RECORD OF BID CLARIFICATION / AMENDMENT				
Project		"Promotion of Youth Employment and Vocational Training in Kenya" (BMZ Reference Numbers: 2016 67 211 and 2016 65 298)		
Procurement name		Supply, Delivery and Commissioning of Equipment for Technical Training Institutes in Kenya: Technical Equipment for Automotive Mechatronics and Body Building		
Procurement ref. no.		ICB-08/MOE-VTT/TVET/KfW 2016 67 211/004/2023-2024		
Clarification No.		1		
Date of Clarification		27.12.2023		
S/N	Question / Clarification Request	Date of Request	Purchaser's Response	Clarification / Amendment
1	The items in these tender are numerous and in some cases technically sophisticated. It will take time to prepare adequate bids. ... We therefore kindly ask you to extend the deadline for bid submission by at least 14 days.	28.11.2023	An extension to the original bid submission deadline is not possible for this tender.	Clarification

# Additional Information to Clarification No.1, S/N 6

**b. Workshop Sections**

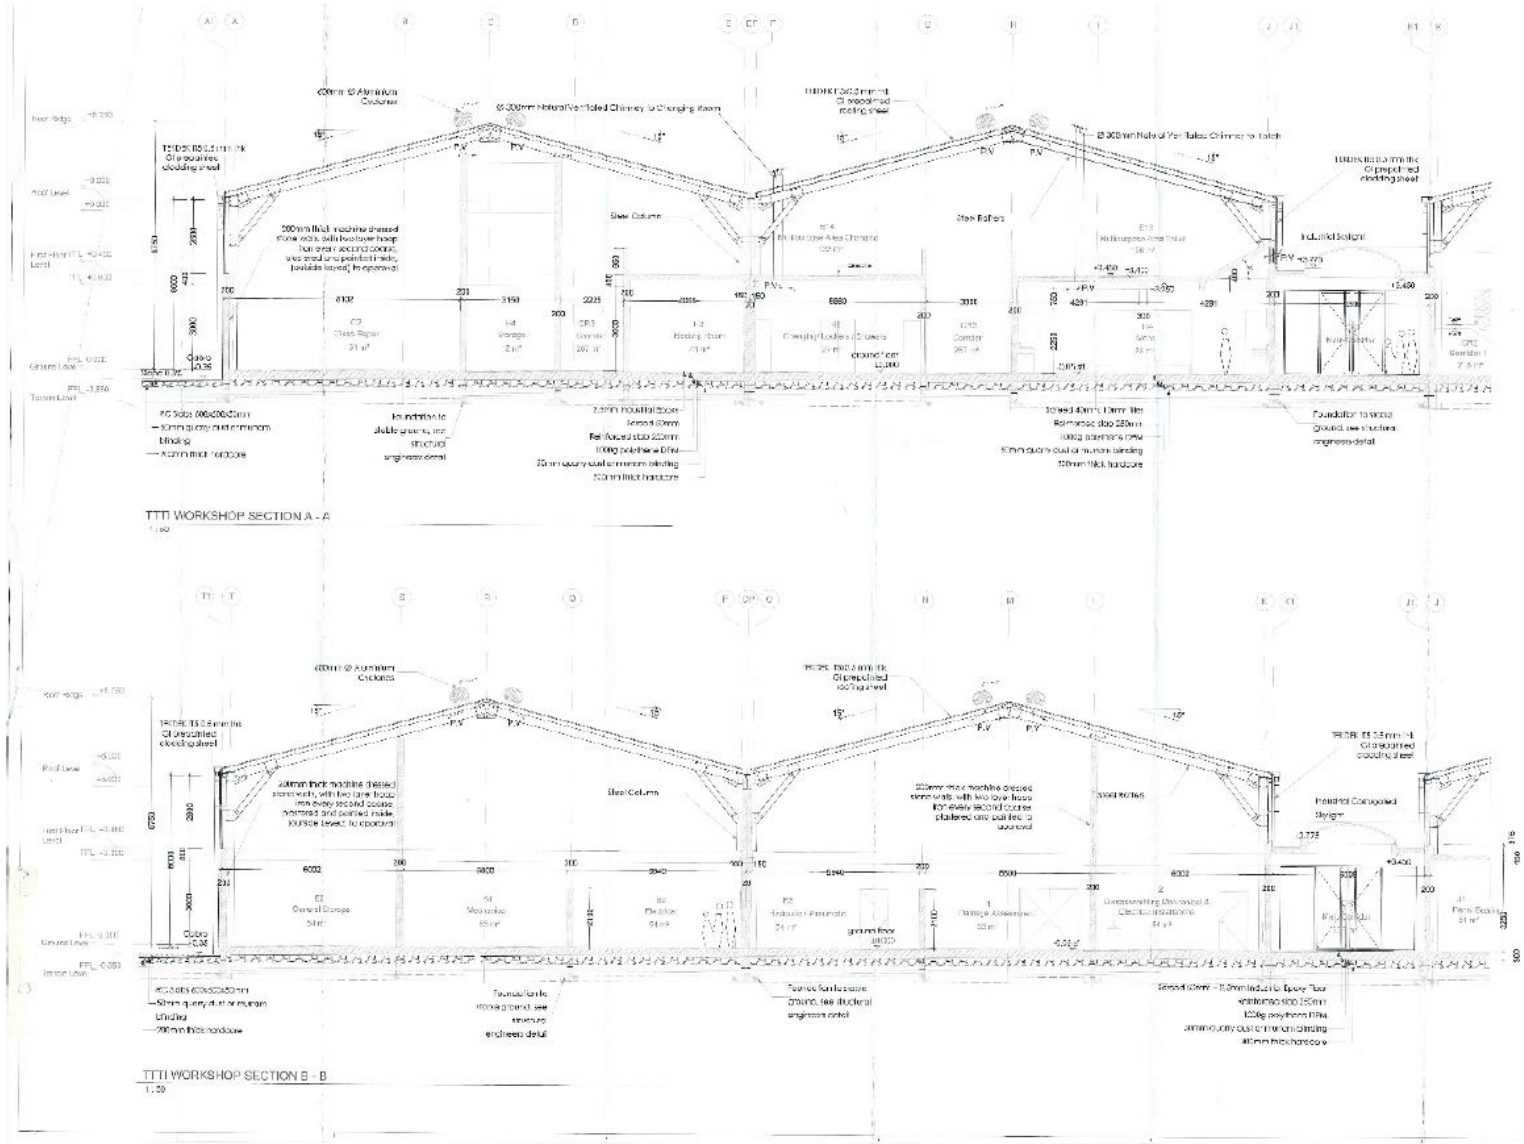
<i>Please confirm that as per the tender documents no extra service such as installation, training and maintenance is required.</i>			
7	<p><b>Item No. T 270 / Item Name: SUB ITEM Ducting for preparation room</b> and <b>Item No. T 334 / Item Name: SUB ITEM Ducting for spray booth</b></p> <p><i>For the exhaust air ducts, we would still need information on how high the chimneys should be from the floor and of course it would help if we had drawings/photos so that we know whether we need 45°/90° bends.</i></p> <p><i>For the supply air too, is it possible to take these directly on an outside wall, for example.</i></p>	05.12.2023	<p><b>General comment:</b> It is important to adhere to the overall measurements of the spray booth / preparation room as indicated in the specifications because the construction of the workshop has been commenced. Therefore, the provided sample of a spray booth / preparation room, or an equivalent product, should be considered in the potential bid.</p> <p>See workshop drawings and sample spray booth attached (or equivalent).</p> <p>Closed cabin with air intake duct (approximately 900 x 900mm) from the workshop. The air supply to the cabin could be from the top or side. The later would require a 90 degree bend. No possibility to connect to the outside wall (see sample attached, or equivalent).</p>	Clarification
